## Technical Memo

**RANK** 3**Revised :****Issued :** December 28, 2021**Subject:** Software Release [V3.01]**Revise Point(s)****Issue No.**

HDCM21-063

MAINTENANCE -> <OUTPUT FORMAT>

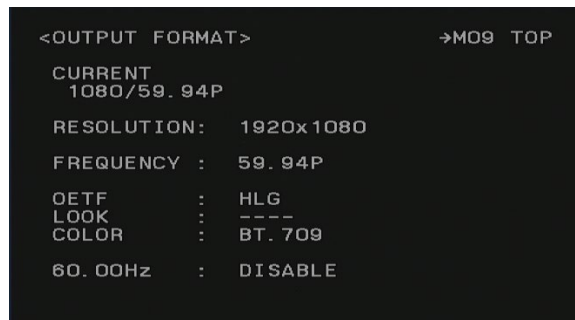
## 3. Supports 60.00Hz format (HDC3100/3170/3500/5500/5000)

Supports 60.00Hz format.

When connected to a CCU, the camera format will switch automatically when the System Format is set to 60.00Hz.

In Standalone mode, you can select the 60.00Hz format by setting "60.00Hz" to ENABLE in the camera menu MAINTENANCE -> OUTPUT FORMAT.

MAINTENANCE -> <CAMERA NUMBER>

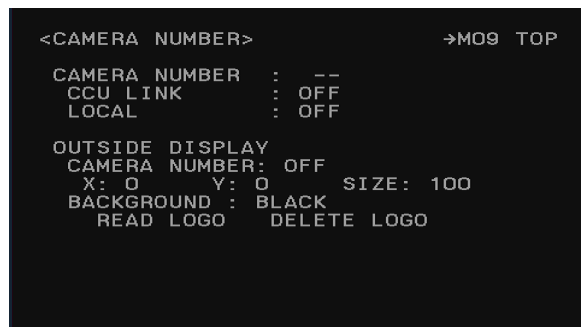
#### 4. Supports CCU Assignment (HDC3100/3170/3500/5500/5000)

Supports CCU Assignment function.

In the "LOCAL" item and "CCU LINK" item on the MAINTENANCE -> CAMERA NUMBER page, the camera number display can be selected from "Set with camera", "Set with camera and supports CCU Assignment", or "Set with CCU and supports CCU Assignment".

LOCAL: ON -> You can always set the camera number in the camera menu.

CCU LINK: (LOCAL) is displayed.

LOCAL: OFF, CCU LINK: OFF -> You can set the camera number in the camera menu.

When the CCU Assignment is enabled, the SYSCAM number set in the MSU is displayed.

LOCAL: OFF, CCU LINK: ON -> You can set the camera number in the CCU menu.

When the CCU Assignment is enabled, the SYSCAM number set in the MSU is displayed.

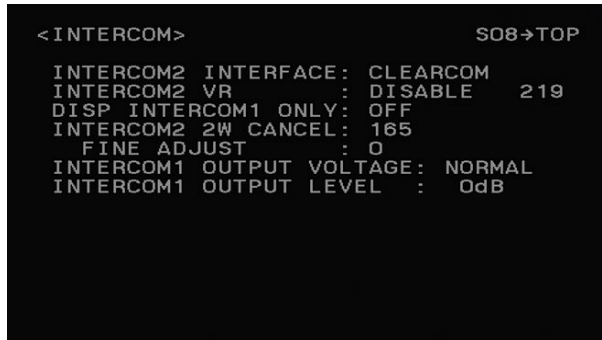
#### 6. Added OPTICAL FILTER setting page (HDC3100/3170/3500/5500/5000)

Added camera menu PAINT -> OPTICAL FILER page so that ND/CC filter can be switched from the menu.

\* For HDC3100/3170, ECC will change if you change the CC filter.
